Access Compliance Report Public Rights-of-Way (Pedestrian Signals)

Intersection ID: N/A	Main Street:	Cross Street: N/A	Location: N/A
ADA ID: A6CFDD1B8399	Signal Type: One Push Button-Non APS	Overall Compliance: No	Severity Score: BTN 1: N/A BTN 2: N/A No BTN: N/A
Codes/Mitigation Info/Possible Solution		Field Measurements/Component Compliance

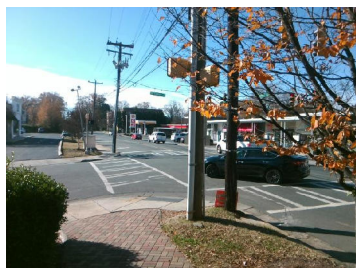
PROW/ADA: R404.3, R404.1, R404.7.1, R404.7.2

Possible Solutions: Provide PAR As Indicated. Provide Clear Space.
